## **Application by Vattenfall Wind Power Limited for the Thanet Extension Offshore Wind Farm Development Consent Order**

### **The Examining Authority's second written questions and requests for information (ExQ2)**

**Issued on 10 April 2019**

Extract from Onshore Land Plans Sheet 2 [REP2-011].  
Excluded land highlighted in purple polygon.

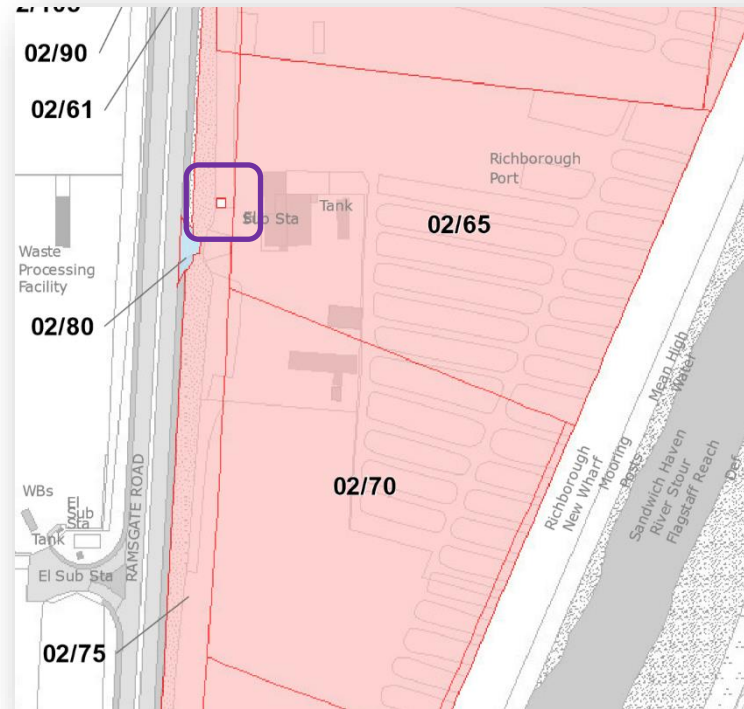
2.3.5.	The Applicant and Ramac	<p><b>Excluded Land: Parcel 02/75</b>                      The Onshore Land Plans identify a small plot of land excluded from the CA request for permanent freehold acquisition on Parcel 02/75.</p> <ul style="list-style-type: none"> <li>a) Can the Applicant please explain the purpose for which this land has been excluded. If the exclusion is in error can the Onshore Land Plans be replaced at Deadline 5.</li> <li>b) Can Ramac please review the Applicant's response to this question at Deadline 5 and if the exclusion is intentional, please identify what effect the exclusion of this land from CA will have on Ramac</li> </ul> <p>{See Land Plans extract identifying the plot}</p>
